## 1938 CHANGES IN MODELS

Since Publication of Each Service Bulletin

Grouped under each model and arranged according to Run No. — Current models included.

SCHEMATIC DIAGRAM SHOWING RUN No.2 CHANGES IN MODEL 38-2 CODE 121. CONNECTING POINTS LABELED IN RESPECT TO SCHEMATIC MODEL 38-2 IN BULLETIN No. 294.

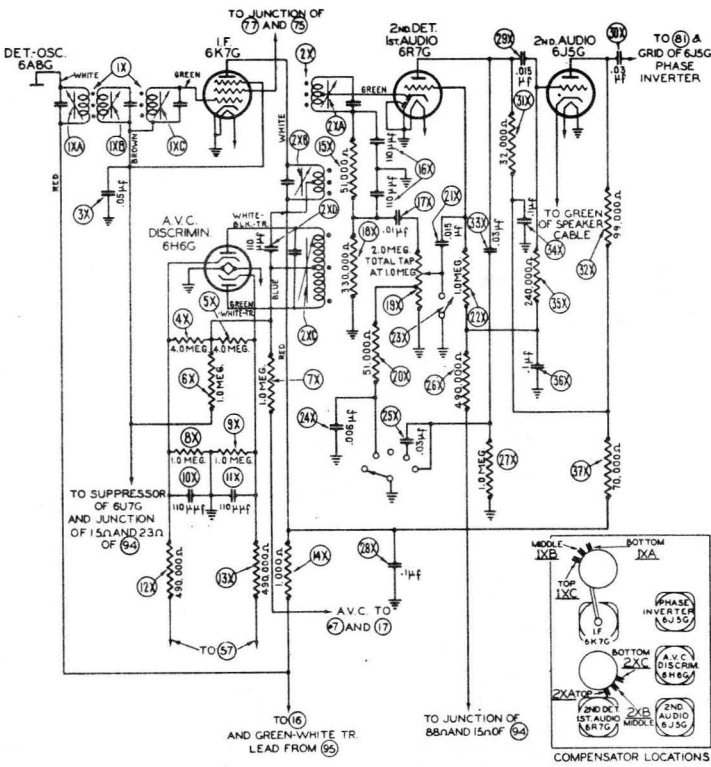
MODEL 38-2	CODE 121	Bulletin 294
The following parts must be changed in addition to the power transformer for 25 cycle operation. Remove (98) condenser .25 mfd., Part No. 30-4446 and replace with condenser, 1 mfd. - .5 mfd. Part No. 30-4549.		
Connect the white wires of condenser, 30-4549 across choke (99) and the red wire to the junctions of (59), (60) and (66). Also, remove electrolytic condenser (96) 8 mfd., Part No. 30-2211 and replace with electrolytic condenser, Part No. 30-2200 16 mfd.		
<b>Run 2</b> Intermediate Frequency Circuit Changes		
Beginning with run 2, the I. F. circuit has been changed to use permeability tuned I. F. transformers. These changes and the locations of the Compensators are shown on the Schematic Diagram below. The schematic part numbers differ from those in Bulletin 294.		
The wires from each circuit, however, on this diagram have been marked indicating the connecting points in the circuit diagram of Bulletin 294.

The Compensator adjustments are as follows:		
A. Set the receiver and signal generator controls as follows:		
1. Range Switch (Broadcast Position).		
2. Volume Control (Maximum).

3. Magnetic Tuning Switch "Off."		
4. Tone Control First Position.		
5. Signal Generator Dial 470 K.C.		
B. Connect the signal generator output cable through a .1 mfd. condenser to the grid of the 6AG5 Det. Osc. tube and connect the cable-ground to the receiver chassis. Set the generator "attenuator" for maximum output. Adjust the I. F. Compensators as follows:

1. Turn compensator (1XB) in until the output meter reading decreases almost to zero.		
2. Now adjust the compensator (1XA) and (1XC) for maximum output; then readjust (1XB) for maximum output.

3. Turn compensator (2XC) in about three turns; then adjust compensators (2XA) and (2XB) for maximum output. The adjustment procedure for compensator (2XC) is the same as that given in the "Magnetic Tuning Circuit Adjustments" of Bulletin 294.

For Schematic Diagram showing Run No. 2 Changes in Model 38-2 Code 121, See Page 4.

MODEL 38-12 - Code 121  
Run 3

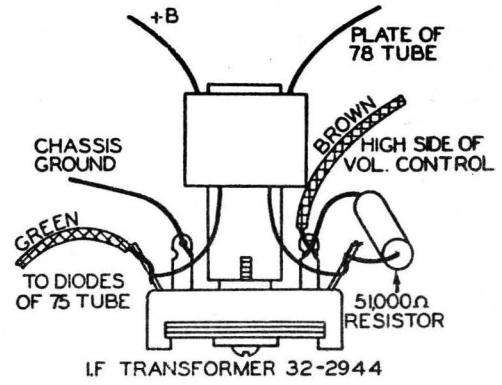
The 2nd I.F. Transformer (12) changed from Part No. 32-2674 to Part No. 32-2944.

Note: Condenser (12B) and (12C) are part of the padder in these transformers.

The wiring of the new transformer 32-2944 is shown on this change notice. For I.F. Transformer 32-2944 See Page 4.

MODEL 38-14 - Code 121, 124  
Run 2

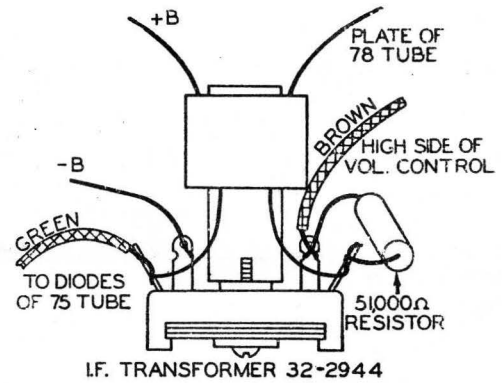
The 2nd I.F. Transformer (17) is changed from Part No. 32-2674 to Part No. 32-2944. The wiring lugs of the compensator on the new transformer are slightly rearranged. A drawing of the transformer is shown on this change notice and indicates the correct wiring point of each lug in the circuit.

For I.F. Transformer 32-2944 see Page 4.

MODEL 38-22 - Code 121, 124  
Run 8  
MODEL 38-23 - Code 121  
Run 4

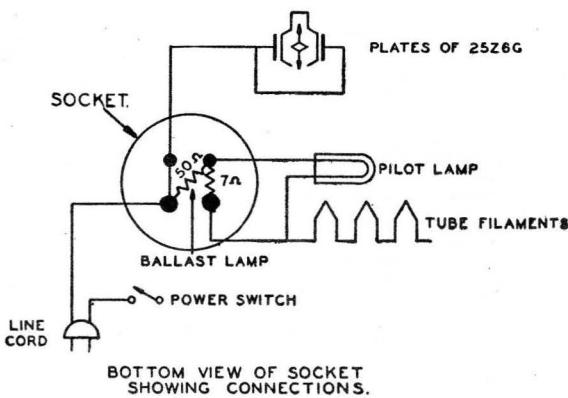
Replaced ballast resistor (51), Part No. 33-3334 with ballast lamp, Part No. 34-2193, for 110 V., A.C., D.C. operation; and pilot lamp (52), Part No. 34-2184 with Part No. 34-2192 in the 38-22 Receiver. The same ballast resistor change is made in the 38-23, the pilot lamp, however, is changed from Part No. 34-2064 to 34-2068.

The wiring of the socket for the new ballast lamp is as shown in the diagram on Page 4.

MODEL 38-15 - Code 121, 124  
Run 5

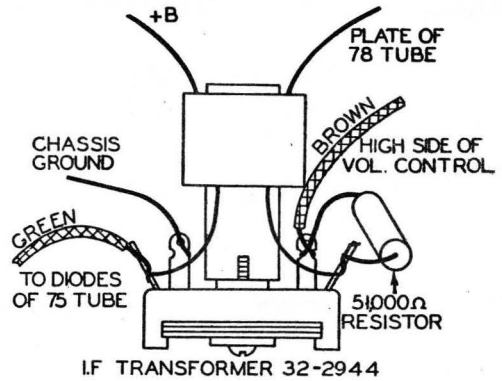
The 2nd I.F. Transformer Assembly 15 changed from Part No. 32-2674 to Part No. 32-2944. The wiring of the new transformer, 32-2944, is shown on this change notice. Condenser (15B) and (15C) are part of the padder in these assemblies.

For I.F. Transformer 32-2944 See Page 4.
